RESPONSE TO SUBMISSIONS DESIGN REPORT

1 BARRACK LANE, 81-83 GEORGE ST, PARRAMATTA

APRIL 2026

2.1 APARTMENT MIX

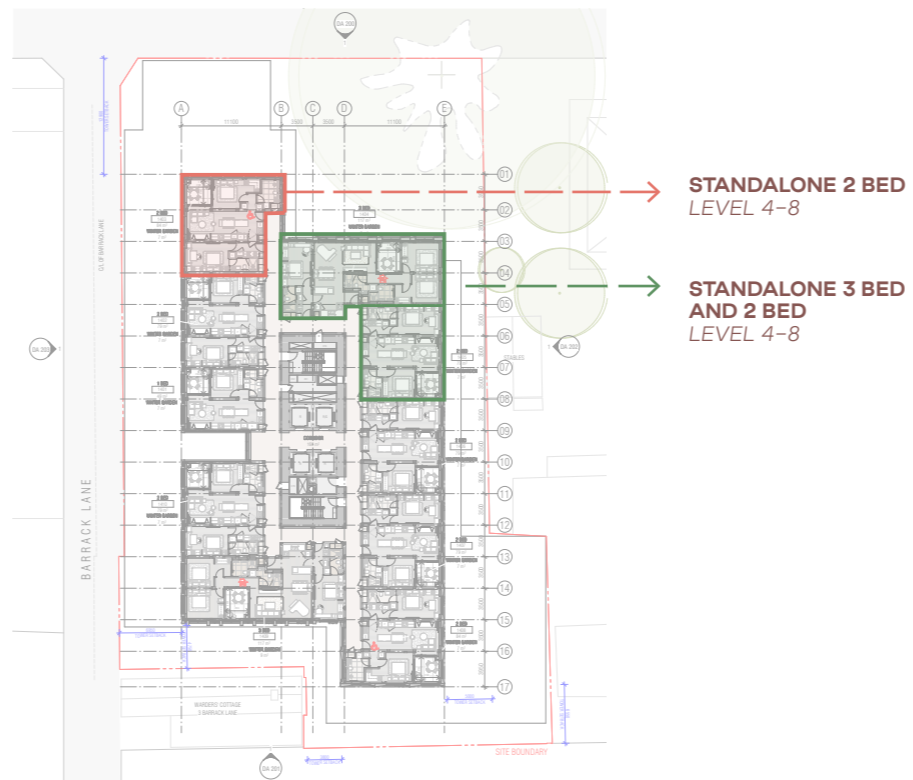
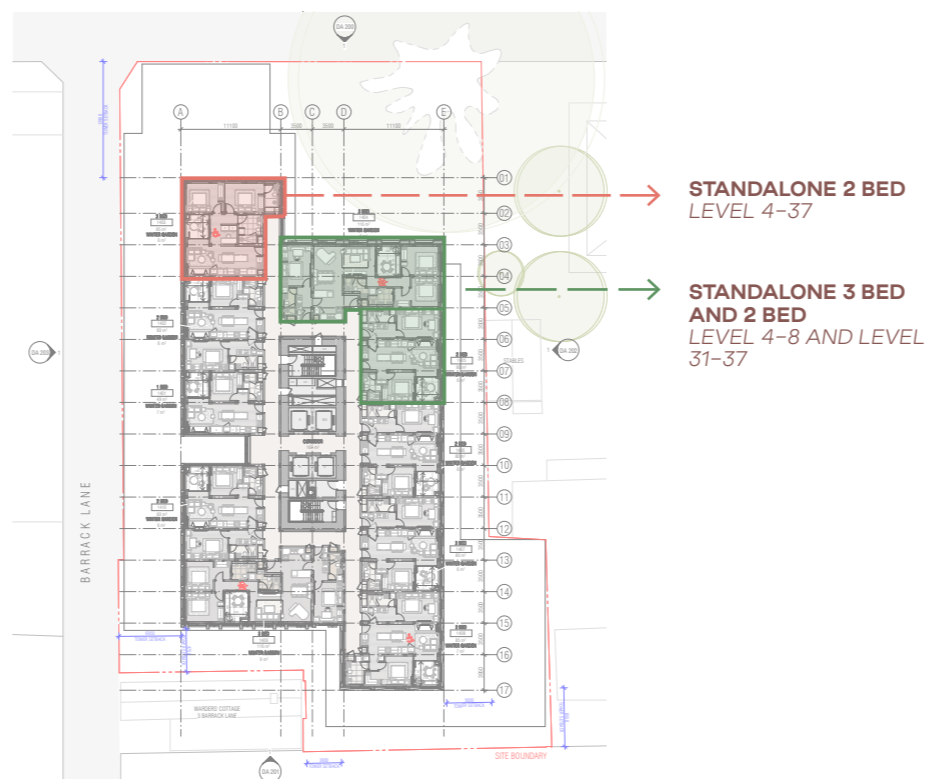
DPHI - 2
COP - 13

In response to the DPHI comments regarding apartment diversity and the proportion of studio dwellings, the apartment mix has been amended. The revised proposal now comprises **50% standalone apartments and 50% dual key apartments**, providing a more balanced distribution of dwelling types across the development.

The updated mix includes an increased proportion of **standalone two-bedroom and three-bedroom apartments**, strengthening the provision of accommodation suitable for larger households. These units are distributed across multiple levels to ensure a genuine contribution to housing diversity within the Parramatta City Centre.

2 BED TYPE 01 LAYOUT

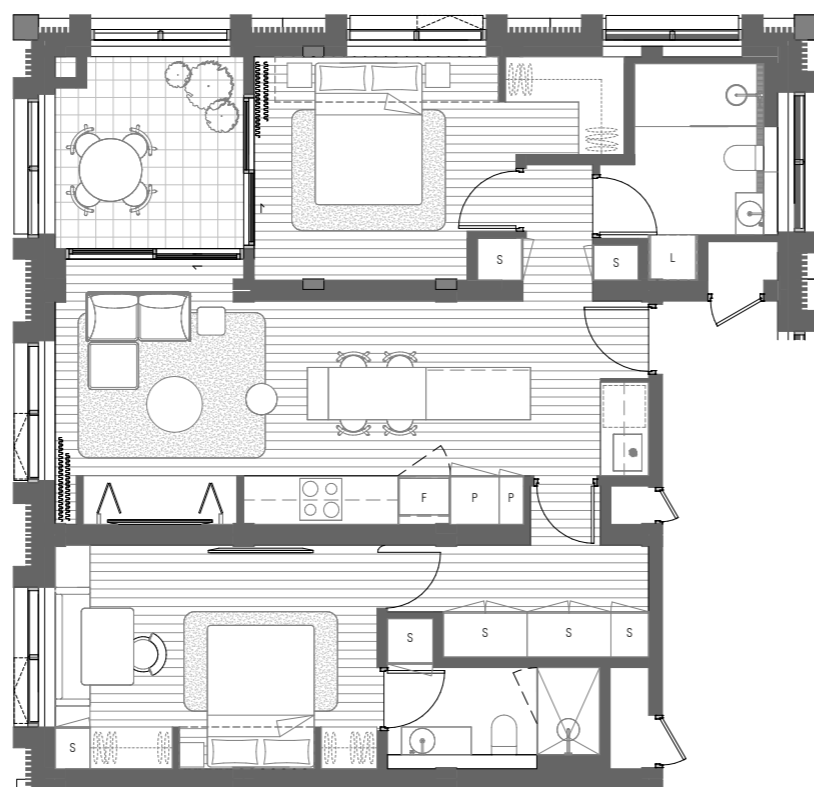
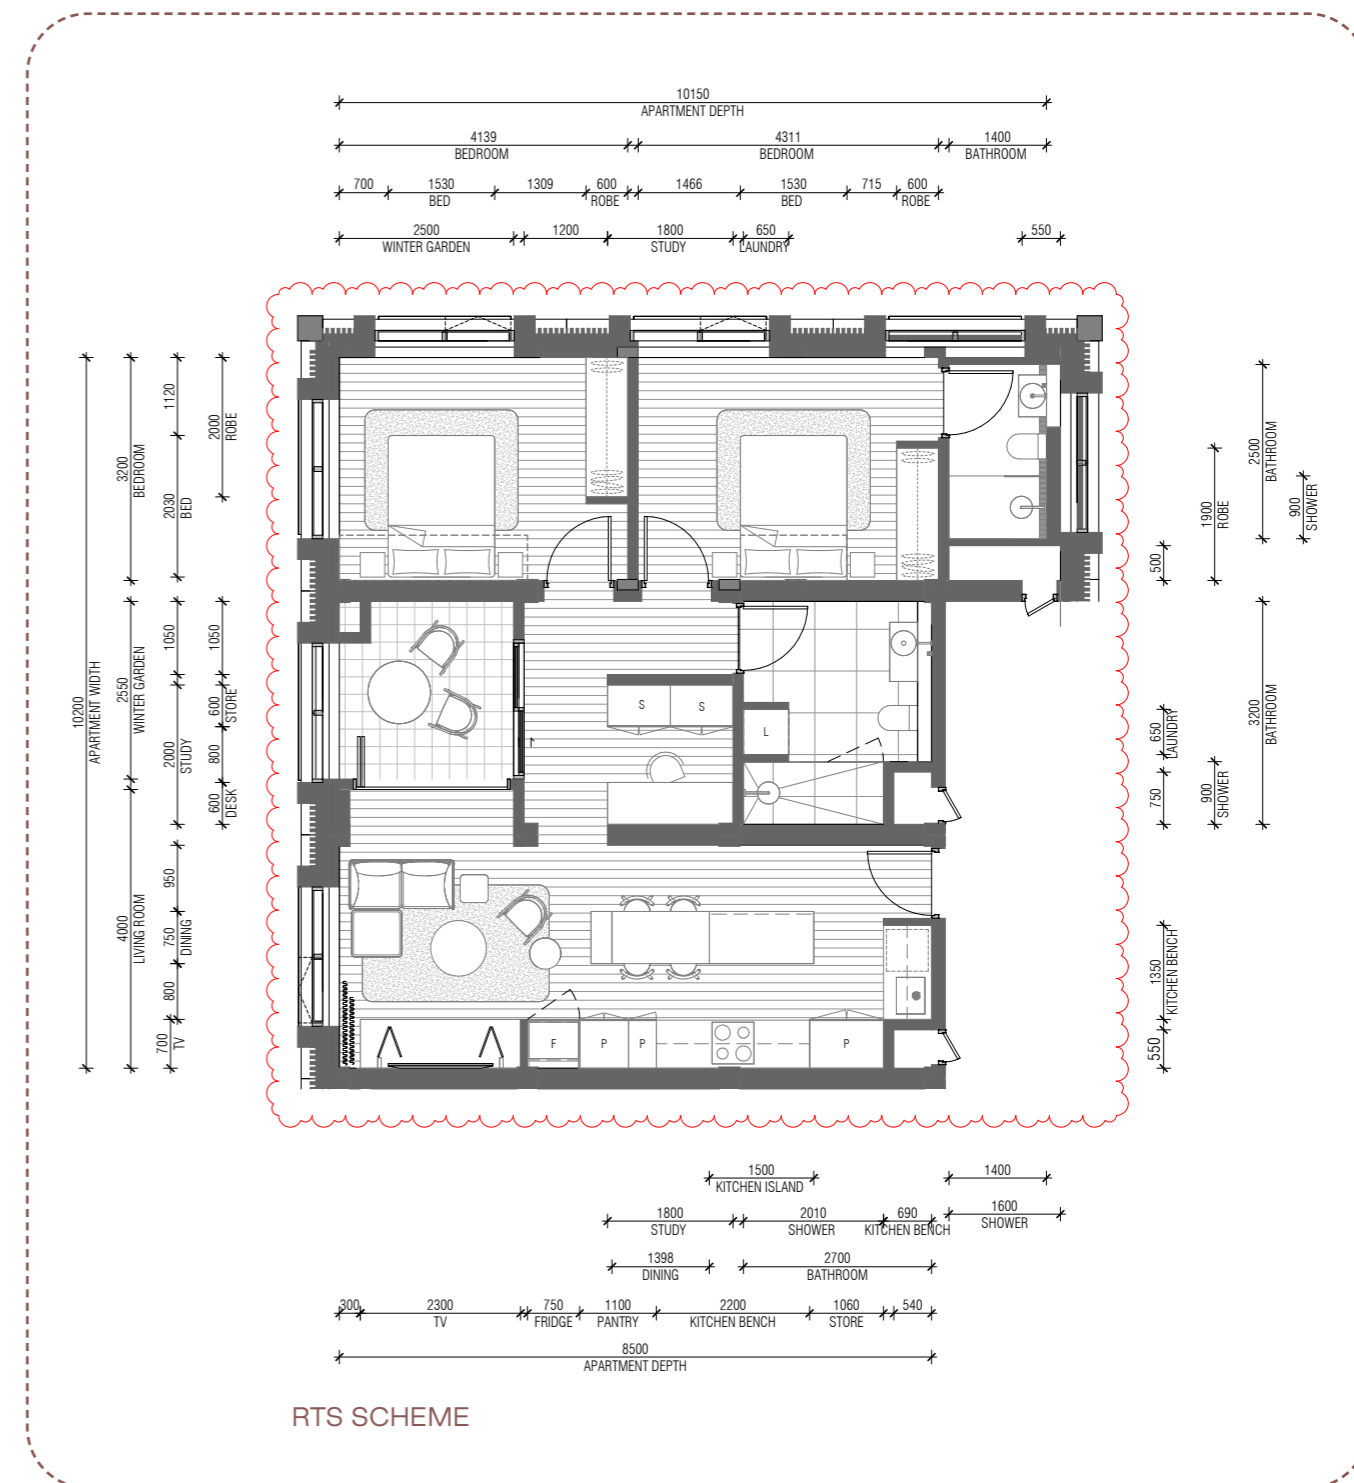
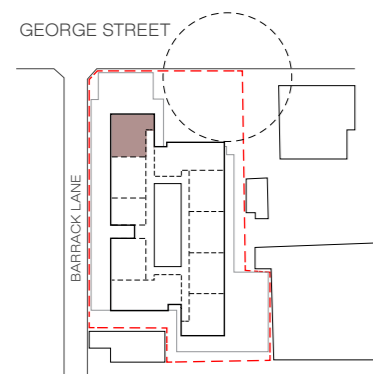
DPHI - 3
COP - 15
COP - 17

The standalone two-bedroom apartments located on the north-west corner have been further reviewed and refined. Amendments have been made to improve the proportion and clarity of the living areas and to rationalise circulation zones, resulting in improved spatial efficiency and usability.

These apartments have been designed as adaptable dwellings. The bathrooms have been dimensioned to enable future conversion to fully compliant accessible layouts, should this be required, without structural alteration.

2 BED TYPE 02 LAYOUT

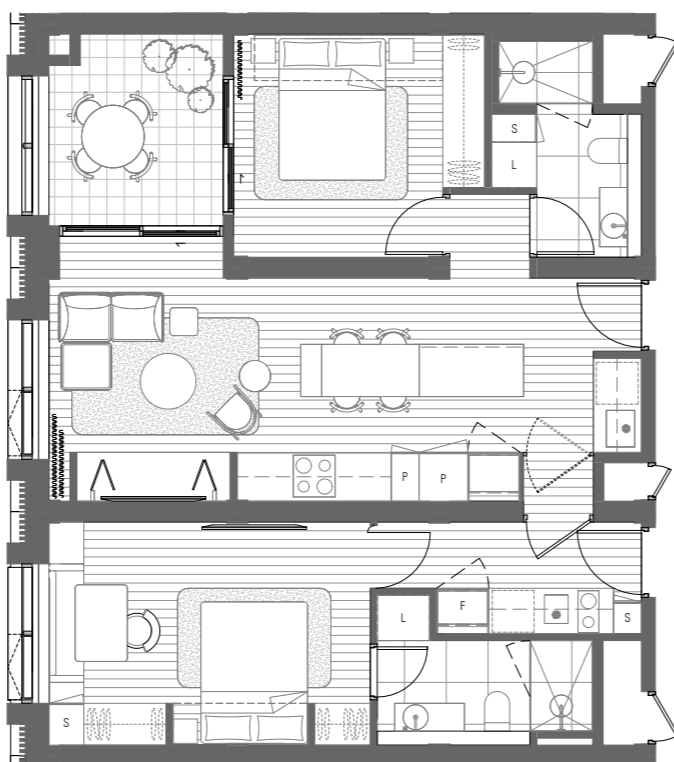
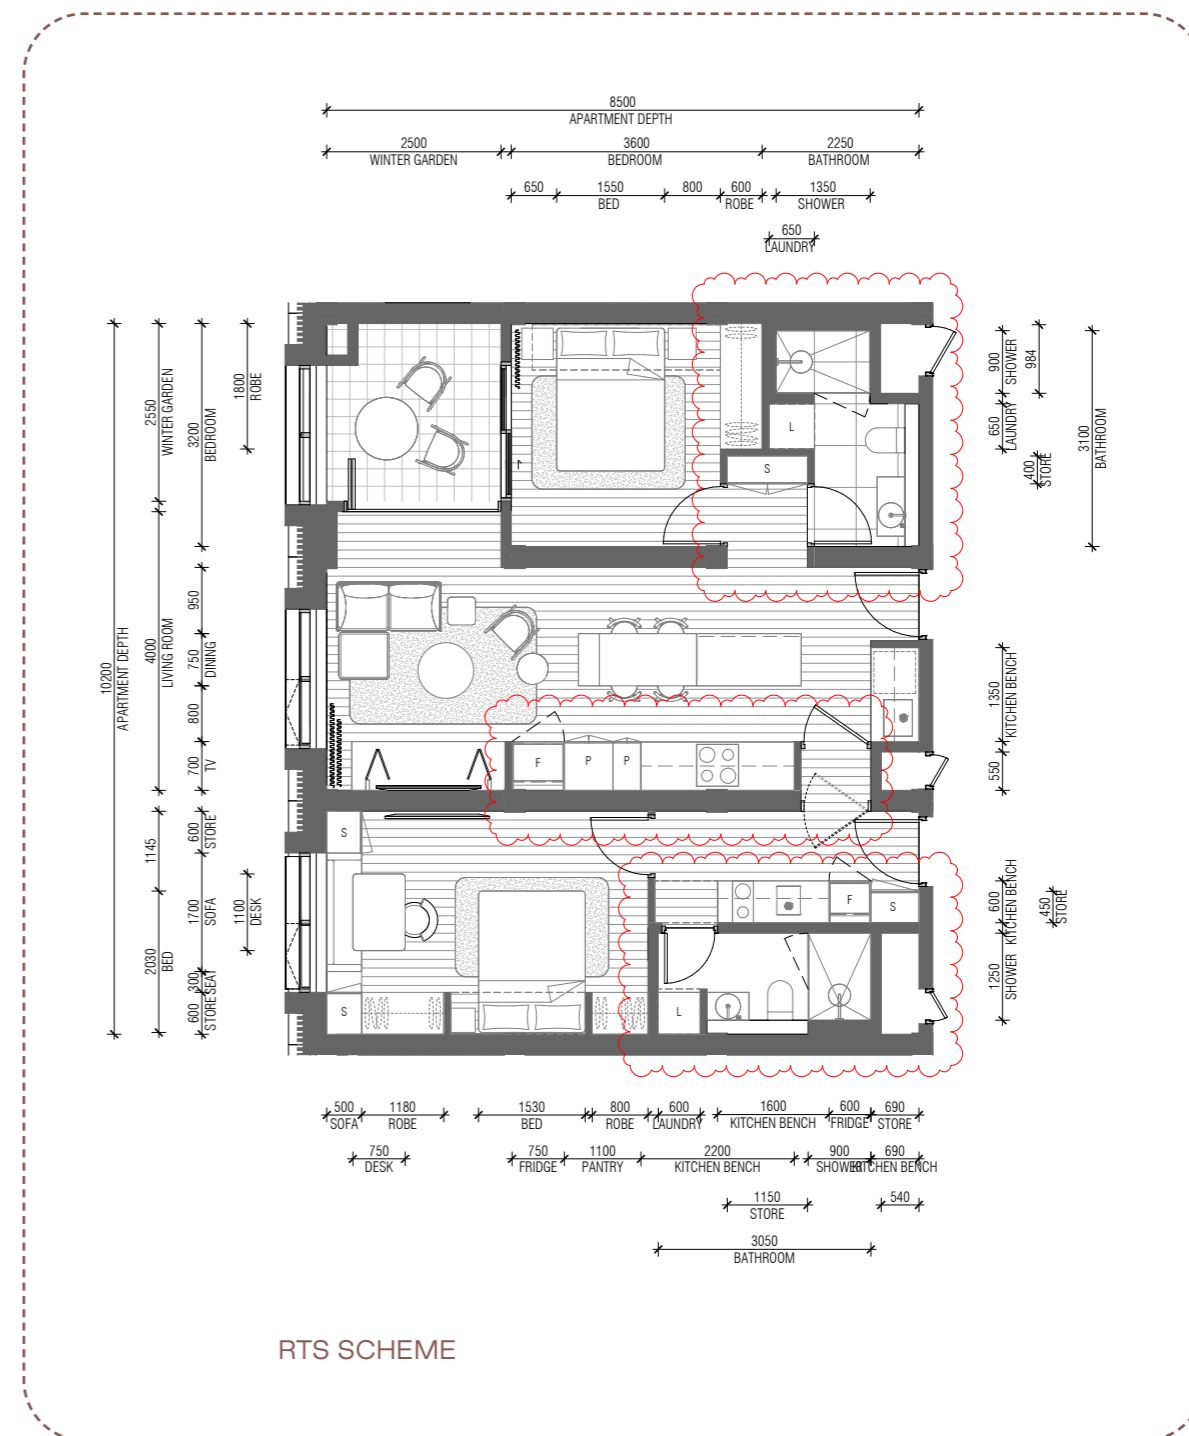
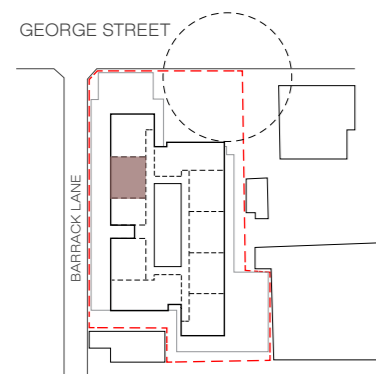
DPHI - 3
COP - 15
COP - 17

The typical two-bedroom dual key apartments have been further refined to improve spatial clarity and internal amenity. The studio component has been reconfigured to provide clearer separation between the living/sleeping area and the kitchen and bathroom zones, resulting in improved privacy and functionality.

The principal living areas have been adjusted to achieve a **4.0 metre living room width**, improving furniture layout flexibility and circulation. Internal planning has also been reviewed to rationalise movement paths and enhance spatial efficiency.

Additional storage has been incorporated within the units to improve usability and long-term practicality. Updated furnished plans demonstrate the revised layouts and confirm functional performance using standard furniture dimensions.

2 BED TYPE 03 LAYOUT

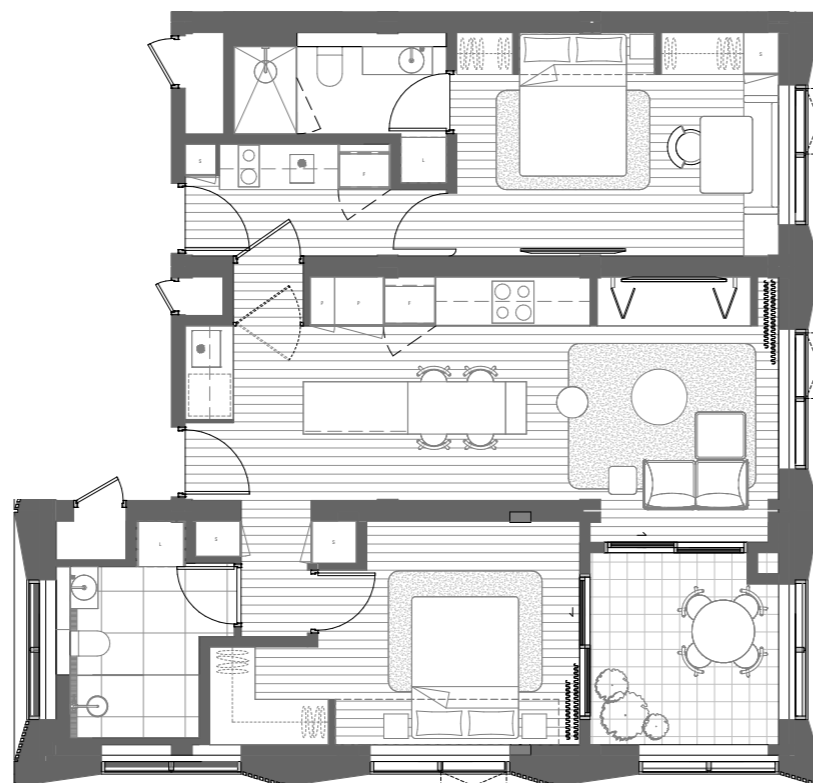
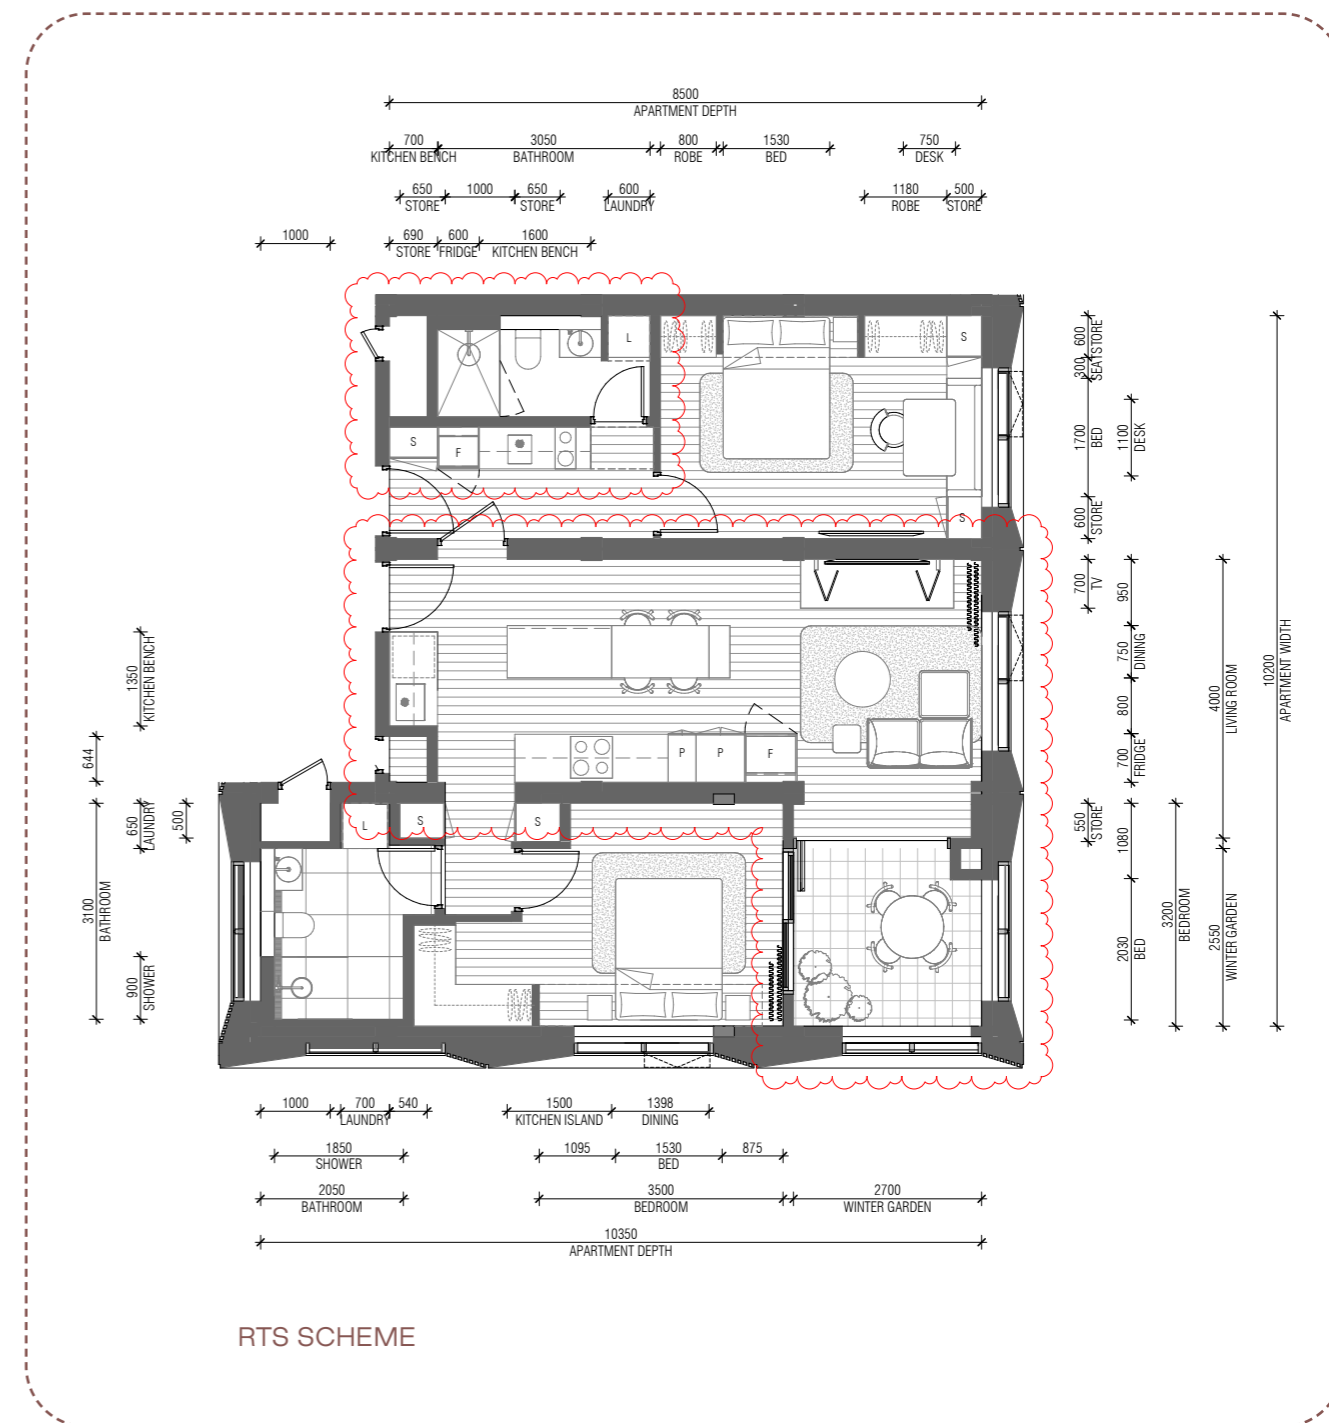
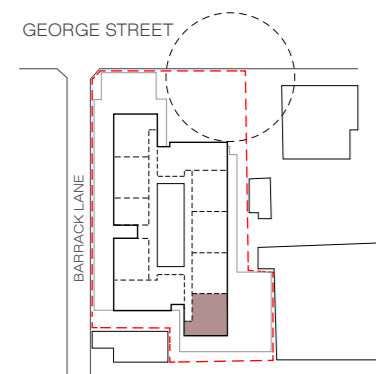
DPHI - 3
COP - 15
COP - 17

The south-eastern two-bedroom apartments have been reviewed and amended to improve internal spatial performance. Revisions have focused on increasing the width of the living areas to enhance functionality and furniture flexibility.

Updated furnished plans demonstrate the revised dimensions and confirm the usability of the spaces using standard furniture layouts.
